### RW Item No. 2

**TOPIC: Warning Signs, NEW Panel with Starburst (SSW-5b)**

## **RECOMMENDED CHANGE TO THE PROPOSED 2009 MUTCD PROVISIONS/ REVISIONS**

Figure 2C-14 (NPA) - Eliminate the “starburst” from the NEW plaque

Figure 2C-14. Supplemental Warning Plaques

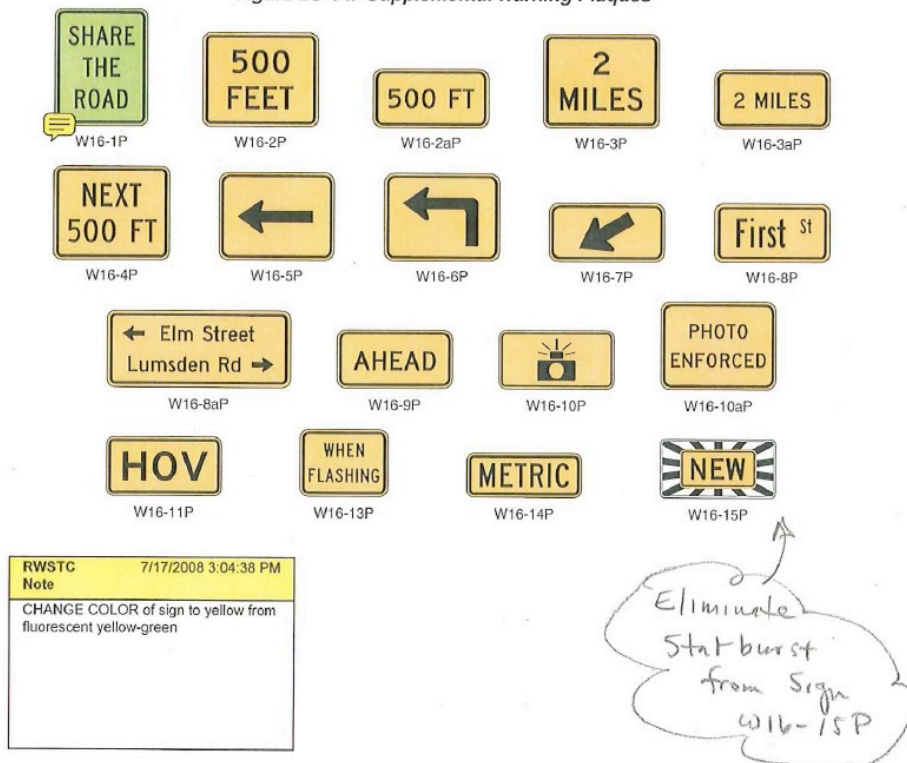
The NCUTCD Council approved changes to Section 2A.15 *Enhanced Conspicuity for Signs*, Section 2C.67 *NEW Plaque* (W16-15P) and Figure in January and June 2008. The panel shown in Figure 2C-14 shows the legend surround by a "starburst" for emphasis. While Section 2A.15 includes a number of forms of emphasis, it does not include the use of the "starburst". For consistency, eliminate the "starburst" from Figure 2C-14 and retain the NEW plaque without the "starburst".

The "starburst" form of emphasis is used in Canada. It is not in common use in the United States. The RWSTC is unaware of any research having been done on the effectiveness of the "starburst". Members of the RWSTC that have seen it in use in Canada and do not believe that adds effective emphasis.
